## REMARKS

### AMENDMENTS TO THE DRAWINGS

**APPENDIX 2: Annotated Sheet 1/6**

FIG. 1A

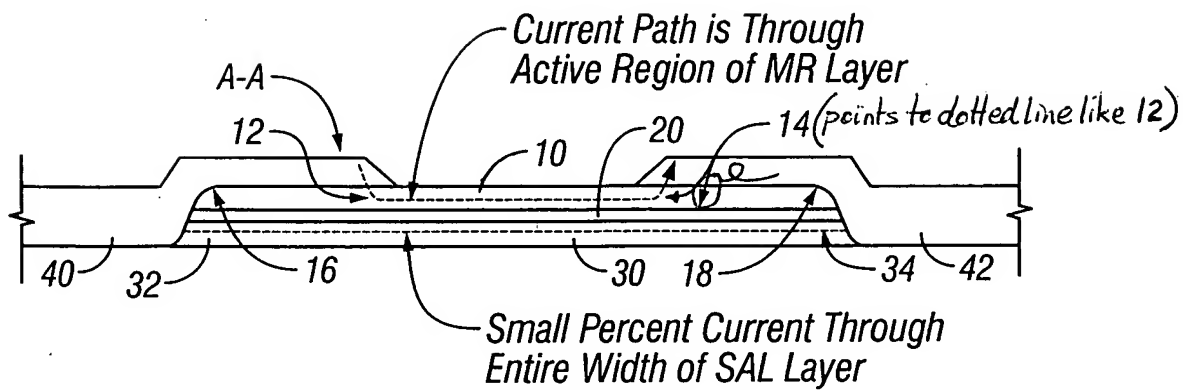
No new matter has been added in amending the specification (including the drawings) or the claims. Pointing the line from reference numeral “14” to the dotted line in layer 10 of FIG. 1A finds support in paragraphs 0039 and 0040 of published application US20040169966. For consistency, the lines from reference numerals “12” and “14” in FIG. 2 are simply placed in the same positions as they appear in FIG. 1A. “ABS” [i.e., airbearing surface] is found in paragraph 0042 of published application US20040169966. On entry of the amendments, an ABS of FIG. 1B is indicated by reference numeral “60ABS.” Furthermore, that reference number “44” does not appear on replacement sheet 1/6 is consistent with the absence of reference number “44” in the text of the specification. In response to a potential ambiguity in the placement of reference number “40” in FIG. 2 (brought to light during the telephonic interview of January 11), Applicants place reference number “40” in FIG. 2 of the “Replacement sheet” in the same position as in FIG. 1A (and, consistent with this re-positioning, remove reference number “40” from FIG. 1B). Other amendments to the specification (including the drawings) find support, among other places, in parent application Serial No. 10/317,878, which the present application incorporates by reference in its entirety in paragraph 0001.

In FIG. 1A of drawing sheet 1/6, please point the line from reference numeral “14” to the dotted line within layer 10 (e.g., in the same way that the line from reference numeral “12” points to the dotted line in layer 10 in FIG. 1A).

FIG. 1B

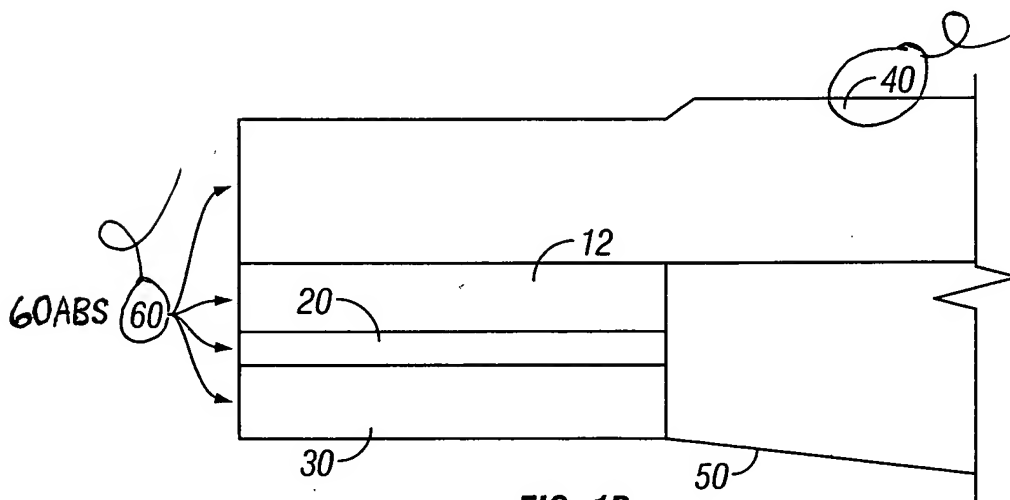
Applicants believe that objections to the drawings noted in the Office Action (*i.e.*, objections in addition to Applicants’ needing to label appropriately new drawing sheet 1/6 as a “Replacement sheet”) were obviated during the interview of January 11. For example, the Office Action stated an objection to FIG. 1B as being inconsistent with at least FIG. 2. Applicants believe the interview resolved this objection because, in the context of FIG. 1B representing a “side-on view” of a cross-section taken along line A-A of FIG. 1A (as noted in the application at paragraph 0018 on page 5, *i.e.*, at paragraph 0034 of published application US20040169966), Applicants understood FIG. 1B as no longer being viewed as inconsistent with FIG. 2 [or FIG. 1A]. As another example, the Office Action stated an objection about reference characters “40” and “62” both being used to designate a longitudinal bias layer stack, and reference characters “42” and “64” both being used to designate a lead layer stack. The interview allowed Applicants to distinguish MR devices from GMR devices, and Applicants believe this distinction resolved the objection. That is, reference characters “40” and “42” are used to designate layer stacks in

In FIG. 1B of drawing sheet 1/6, please add “ABS” to reference numeral “60” and delete reference numeral “40.”

FIG. 2

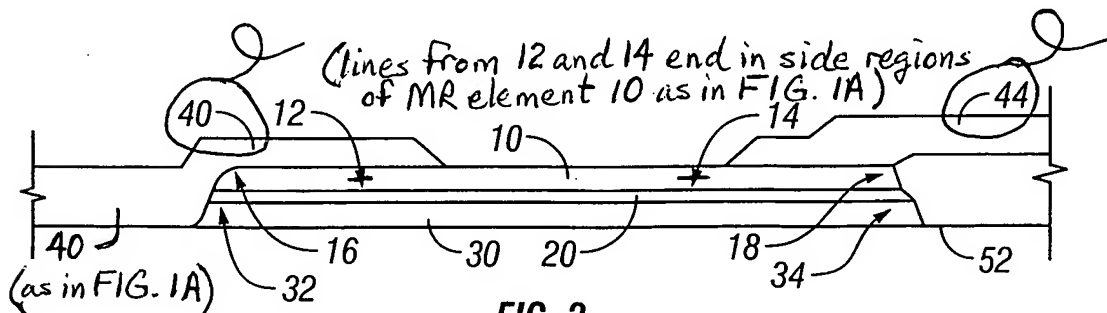
In FIG. 2 of drawing sheet 1/6, please delete reference number “44” and move reference number “40” in FIG. 2 to the same position that it occupies in FIG. 1A. Also please end the lines from reference numerals “12” and “14” in FIG. 2 in the respective side regions of MR element 10 (as the lines from reference numerals “12” and “14” end in respective side regions of MR element 10 in FIG. 1A)..
